## Proposal Request

Architect’s Project Number: 993A  
Proposal Request Number: 053  
Proposal Request Date: 05.13.2024

# PROPOSAL REQUEST 053

## Rooftop Loudspeakers

Contents:  
**FIRE PROTECTION - LEVEL 4 RCP - AREA A**

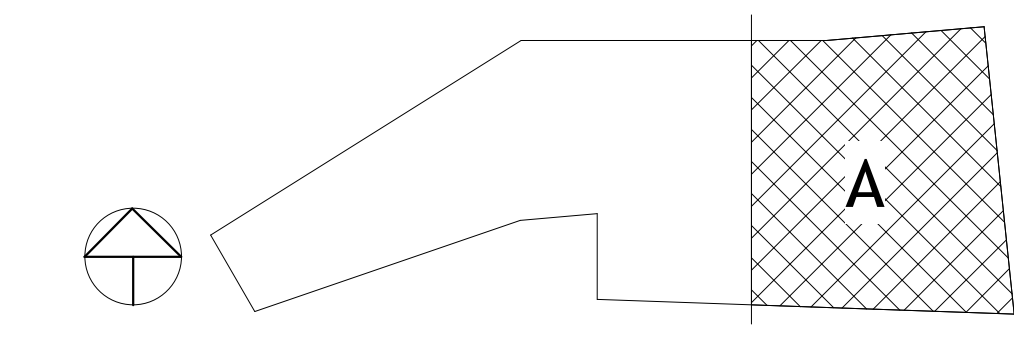
- a) Refer to Revised Sheet **FP104A**, with original issue date 02.24.2023 and revised date 05.10.2024.
  - Detail 1:
    - (1) Revised fire protection plans to show manufacturer specific loudspeaker amplifier.
    - (2) Revised plan notes pertaining to amplifier panel model, settings, and installation.
- b) Refer to Revised Sheet **FP105A**, with original issue date 02.24.2023 and revised date 05.10.2024.
  - Detail 1:
    - (1) Revised fire alarm loudspeaker layout on the roof.
    - (2) Revised plan notes pertaining to loudspeaker model, settings, and installation.
- c) Refer to Revised Sheet **FP501**, with original issue date 02.24.2023 and revised date 05.10.2024.
  - Details 5, 6, 7, and 8:
    - (1) Revised fire alarm loudspeaker details based on manufacturer change to show specific requirements for mounting, installation, and required accessories.

- F6 PROVIDE ENCOMPASS LT 300W AMPLIFIER PANEL TO POWER ROOF MOUNTED T20A10 LOUVER/SPEAKERS. PROVIDE END-OF-LINE MODULE FOR SPEAKER MONITORING. COORDINATE WITH ELECTRICAL AND POWER FROM SPARE 20A, 120V CIRCUIT IN PANEL L4A.
